# HISTORIC AND DESIGN REVIEW COMMISSION

July 19, 2023

**HDRC CASE NO:** 2023-227  
**ADDRESS:** 217 VANCE ST  
**LEGAL DESCRIPTION:** NCB 733 BLK 5 LOT 15, & E IRR 8 FT OF 14  
**ZONING:** R-6, H  
**CITY COUNCIL DIST.:** 1  
**DISTRICT:** Lavaca Historic District  
**APPLICANT:** Vicki Yuan  
**OWNER:** WALLACE ANNE REYNOLDS  
**TYPE OF WORK:** Demolition of a rear accessory structure and new construction of a 1-story rear accessory structure  
**APPLICATION RECEIVED:** June 05, 2023  
**60-DAY REVIEW:** August 4, 2023  
**CASE MANAGER:** Rachel Rettaliata

1. Demolish the existing 1-story rear carport structure.
2. Construct an approximately 864-square-foot, 1-story rear accessory structure.

SITE PLAN  
SCALE: 1/8" = 1'-0"

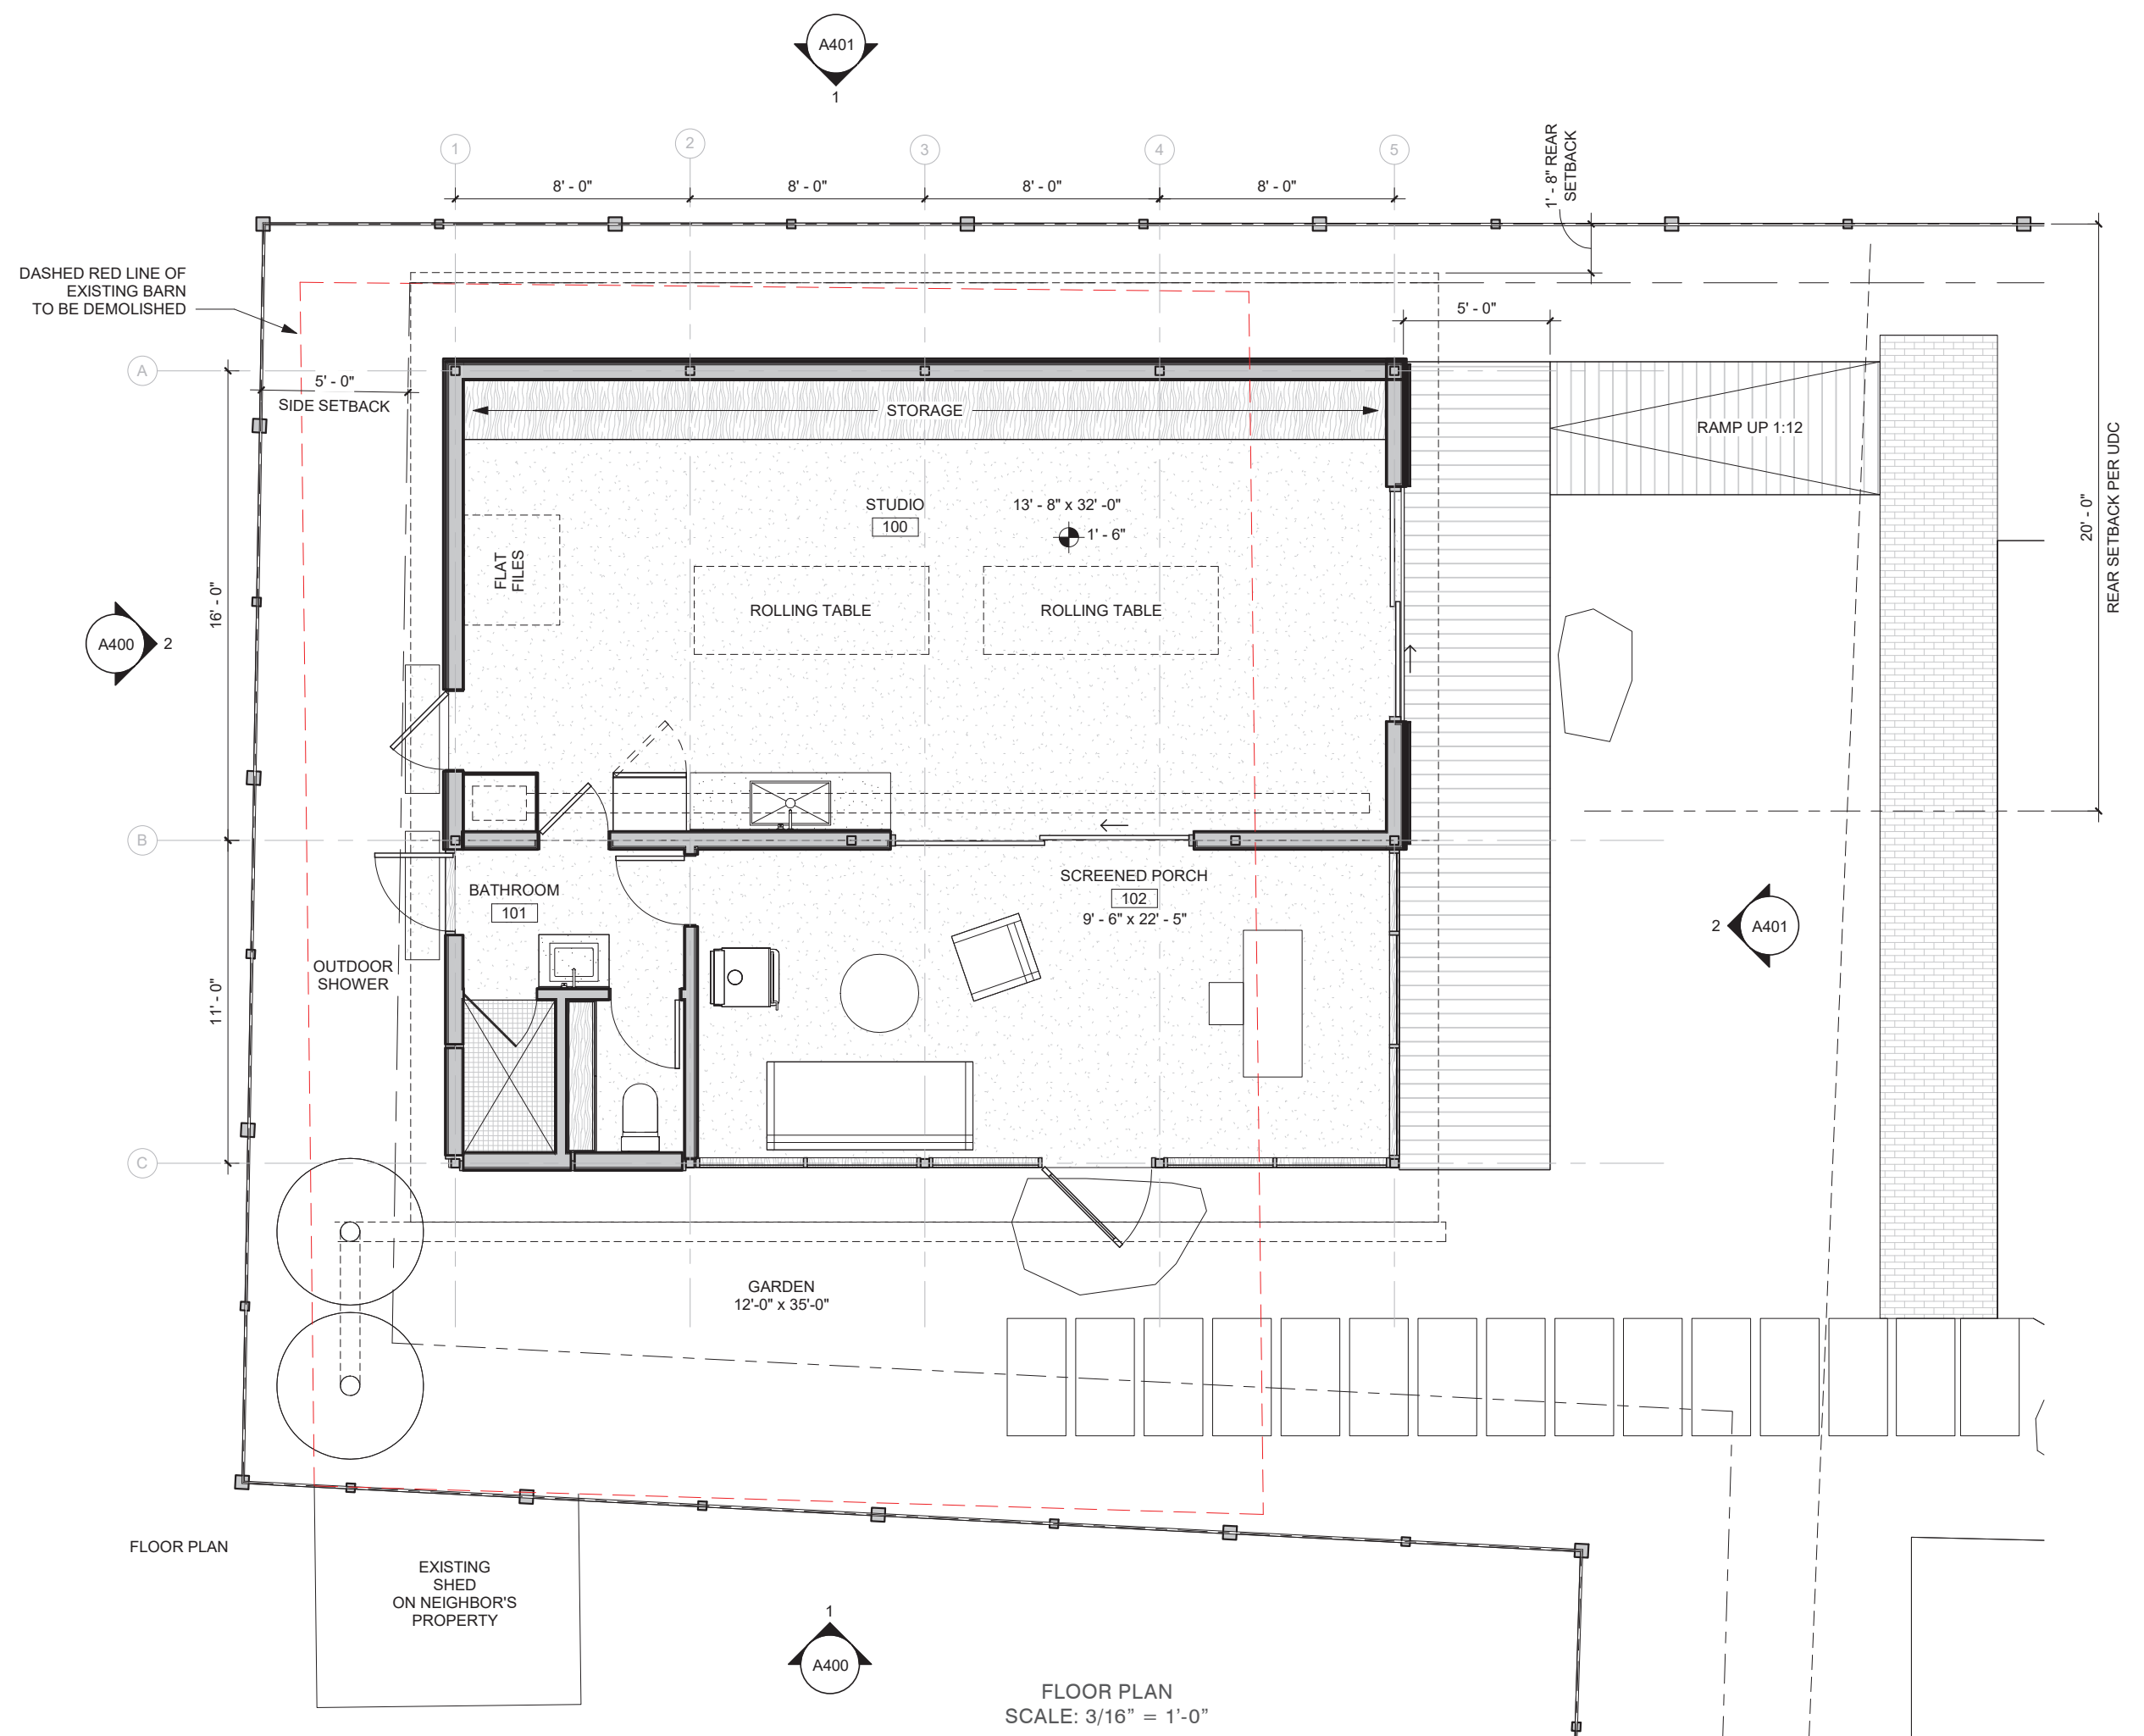
- 2a. SETBACKS & ORIENTATION – The applicant has proposed to construct a 1-story rear accessory structure with a screened porch in the location of the existing carport structure. The proposed footprint of the new rear accessory structure is approximately 864 square feet, including a 512-square-foot studio space with an attached 352-square-foot screened porch. According to the Guidelines for New Construction, the orientation of new construction should be consistent with the historic examples found on the block. The applicant has proposed to orient the proposed rear accessory structure with the primary orientation facing east to the remainder of the property at 217 Vance, which reflects that of the existing structure currently on the site. The applicant has proposed to set the rear accessory structure 5 feet from the west and south property lines and 1'-8" from the rear property line. Staff finds the orientation appropriate and consistent with the existing structure and finds that the applicant must meet all setback standards as required by city zoning requirements and obtains a variance from the Board of Adjustment if applicable.

- 2c. FOOTPRINT – The applicant has proposed a footprint of approximately 864 square feet, including a 512-square-foot studio space with an attached 352-square-foot screened porch. According to the Historic Design Guidelines, new construction should be consistent with adjacent historic buildings in terms of the building-to-lot ratio. Additionally, Guideline 2.D.i for New Construction states that the building footprint for new construction should be limited to no more than 50 percent of the total lot area. The proposed rear accessory structure features a smaller footprint than the existing 1,200-square-foot carport structure. Staff finds the proposal appropriate.

- i. That the applicant meets all setback standards as required by city zoning requirements and obtains a variance from the Board of Adjustment if applicable based on finding 2a.
